# NSTX-U OH Fault Report on Extent of Condition

J. Hosea (chair), R. Ellis, N. Greenough, D. Mueller  
May 26, 2015

# Charge to the Committee

Original implementation of OH water connections

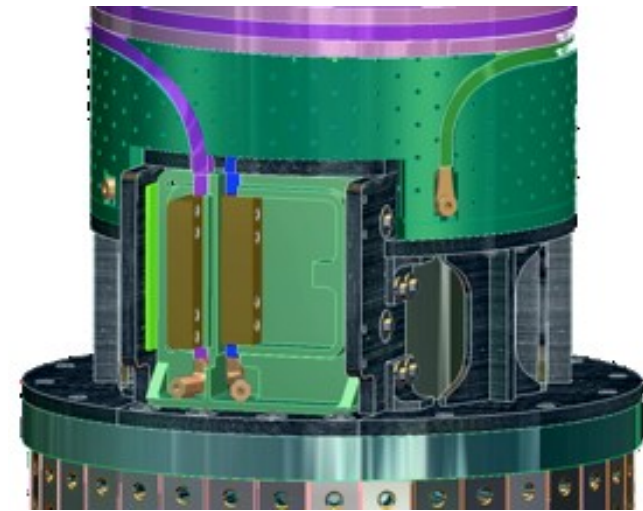
- Need an approved design with proper insulation - underway .
  - Original parts were field fit.
  - New design must have electrical engineering input to insure proper high voltage insulating techniques - underway.

OH lead blocks

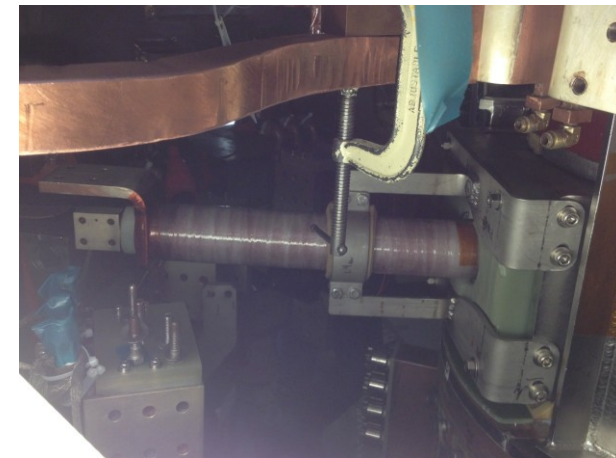
- Must insure integrity of joints – measure voltage drops for test current.
  - Use temperature stickers.
  - Check periodically
    - How can they be viewed?
  - Inner joints from coax connector to coil are insulated on side – measurement via water feed should be possible.
  - View accessible stickers periodically with borescope.
- Evaluate design assumptions – particularly with regard to the need for support of the inner conductor – and determine whether the feed must be potted, or if a system of shims around the inner conductor, is feasible.
  - The coax feed should be potted unless there is justification for altering the present design and requirements.
  - Be sure the design, construction, installation and analysis of the connector box are also consistent.
- Review the “high voltage hygiene” in the connector box.
- Consider a means of detecting series joint arcs in connector box.

# TF Outer – Inner Electrical Connections

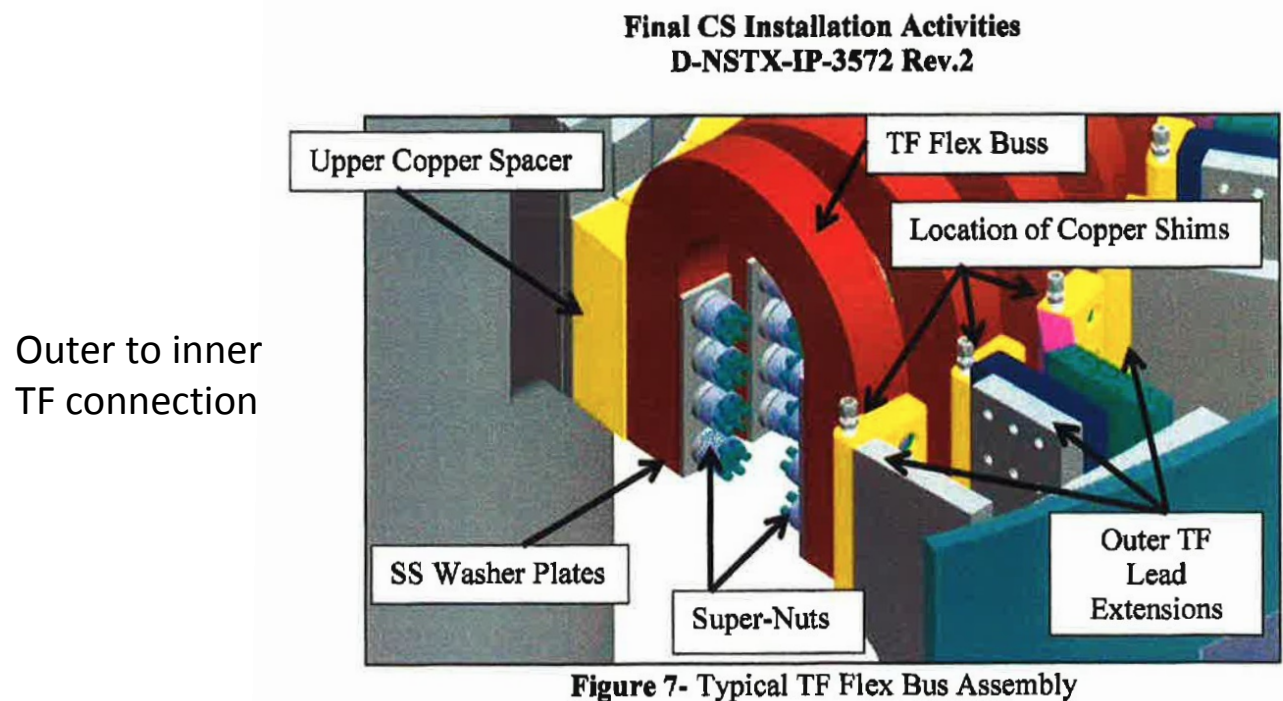
- Critical connection with several elements in series.
  - Fit-up is critical.
- Accurate joint resistance measurements are required.
  - NSTX-U has relied on purely mechanical measurements of joint characteristics. [torque, feeler gauges]
  - Investigate if techniques exist for proper measurement of joint resistance. Voltage across the TF inner leg connection can be measured via the water connection with current running through the connector assembly and the leg

Tarnish on silver plated connectors

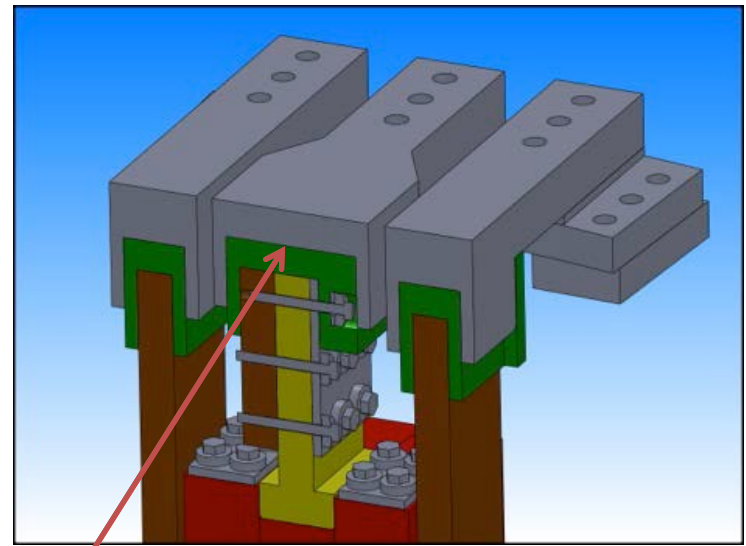
- Improve quality and uniformity of silver plating of contact surfaces.
  - Tarnishing of silver plated areas has been observed.
  - Variable thickness, observable by eye, of silver plating?
- Cracking of G-10 spacers on TF connector restraints
  - Structural adhesive will now be used to fill joints
  - Any analysis on its performance?
- Use temperature stickers, monitor with a borescope or camera/fiber optic bundle.

G-10 caps that cracked → improve contact with structural adhesive??

# PF1A, 1B, 1C Considerations

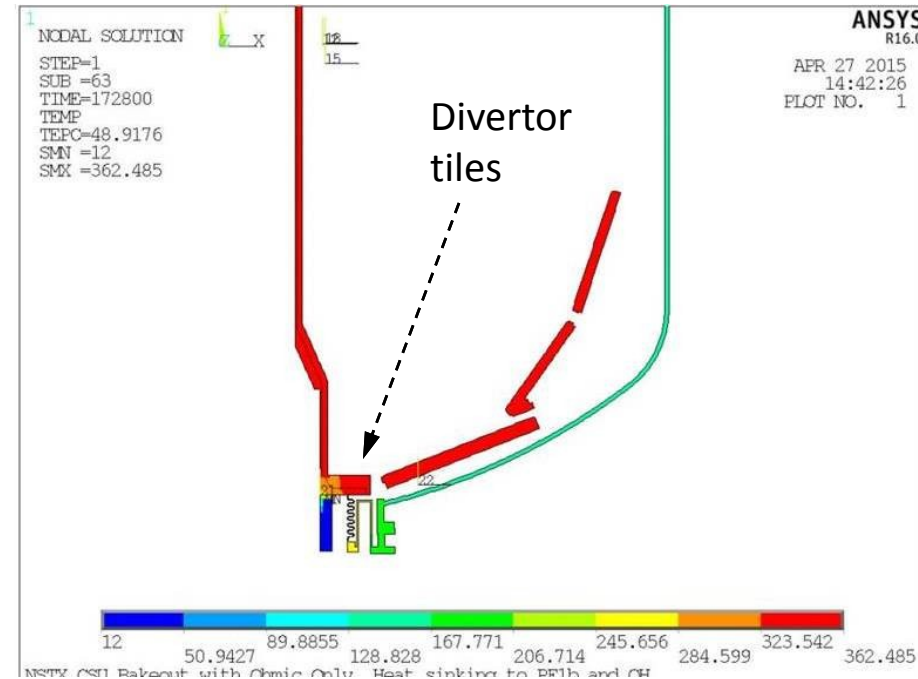
- Shorting between PF-1A ground wrap and OH ground plane.
  - It cannot be repaired without removing center stack.
  - What are the ramifications? Minor.

- PF-1C can be heated by the plasma
  - Only a minor issue when PF-1B is not energized, but the strike point can still hit the PF-1C can.
  - Energizing PF-1C so as to push the strike point towards the plasma will avoid this.

- Divertor tiles will not reach adequate temperature unless heated by the He system.
  - If heated by He, the G10 spacer and ground wrap of PF-1B will exceed allowable limits.

- There is also the issue of stress in the welds securing PF-1B upper and PF-1A upper.
  - Management must decide whether to bake to over 300C and accept risks to PF-1B

- Operations can administratively avoid the problem.
  - A clear set of operating constraints needs to be developed.
- Bakeout issue with PF-1B (Art Brooks analysis)

- Connections to divertor plates must be able to accommodate the He heating system.
